Service Bulletin

No. : MZ07-052

Model: SR7500, SR8500

Subject: Software Update

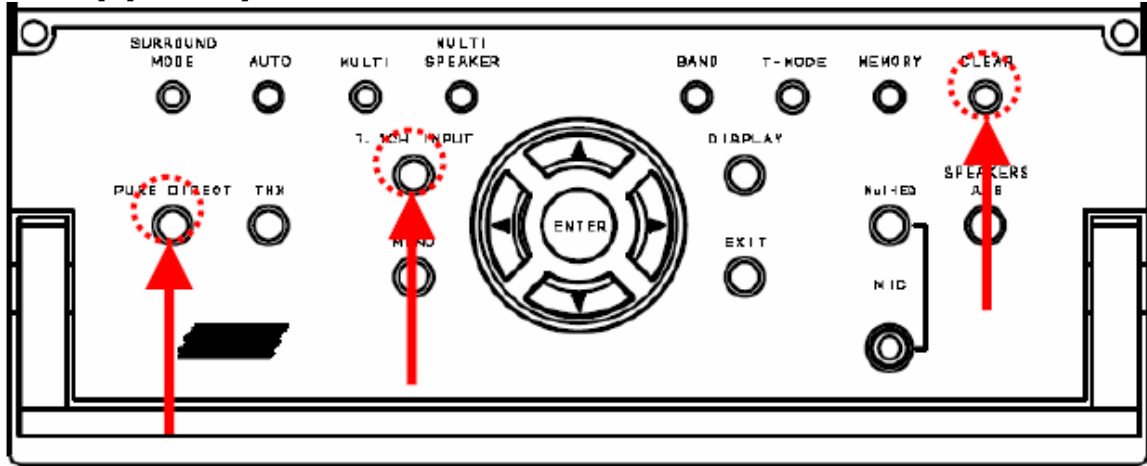
Originally, the unit was designed to go into STANDBY mode with the STANDBY LED flickering every 500m sec. upon detection of an abnormality. The unit would never be powered on by the standby switch or the remote control, so over dissipation never occurred. However, if the unit was unplugged and plugged in again, component over dissipation could occur before the unit went into standby a few seconds later.

The unit has been modified never to be powered on by any means once it goes into standby with the standby led flickering every 125m sec., unless a specialized procedure (*1 described below) is performed.

*1: If the unit cannot be powered on after being plugged in again (with the STANDBY LED flickering every 125m seconds), the power amp has failed. The unit still can be powered on again through the following method, but it can further damage the power amplifier. Never let end-users perform this procedure.

Can be powered on by “FACTORY KEY”=[PURE DIRECT]+[7.1 CH INPUT]+[CLEAR]
